Applies To: **2007 MDX – ALL**

**2008 MDX – From VIN 2HNYD28..8H50001 thru 2HNYD28..8H514713**

## A/C Whistles While in Recirculation Mode

(Supersedes 08-014, dated April 11, 2008, to update the information marked by the black bar)

**NEW BLOWER UNIT**

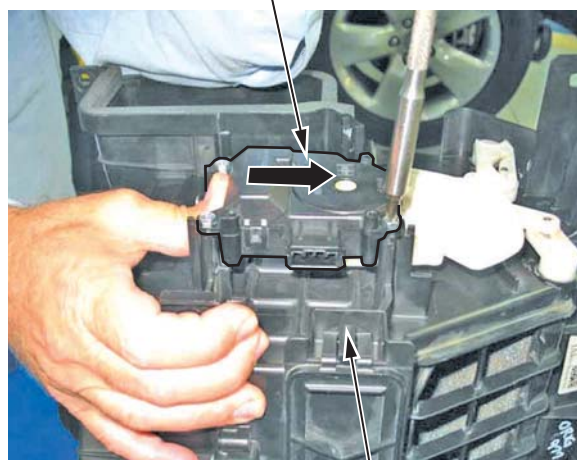
**NOTE:** Make sure the recirculation control motor is adjusted to the highest point possible by pushing the motor toward the top of the unit, and then tightening the screws.

**RECIRCULATION MOTOR**  
(Push on it while tightening the screws.)
